ADMINISTRATIVE AMENDMENT

SITE PLAN
DRB

SP-DRB-A

HILAND PLAZA

A1 SITE PLAN - DRB

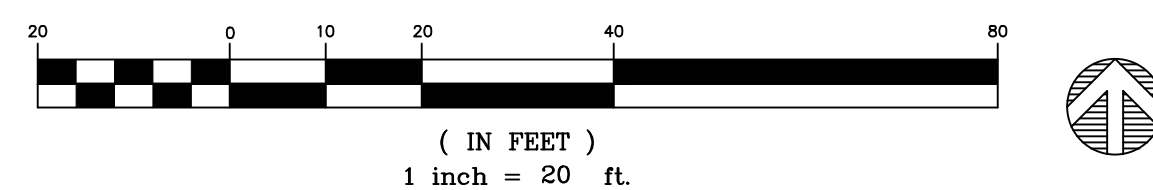
REVISIONS: JUNE 27, 2023
ADA accessible parking dimensions and associated pavement markings updated

REVISIONS: JUNE 23, 2023
Future PV (Solar canopy) @ parking
ADA compliant ramps relocated
EV parking updated

DEVIATION APPROVED WITH THIS SITE PLAN
TO ALLOW FOR 3'-6" TALL PATIO RAILING
ABOVE CONCRETE PATIO THAT IS UP TO 30"
ABOVE PUBLIC SIDEWALK AT THIS LOCATION
AS REQUIRED BY GUARDRAIL DEFINED IN
INTERNATIONAL BUILDING CODE
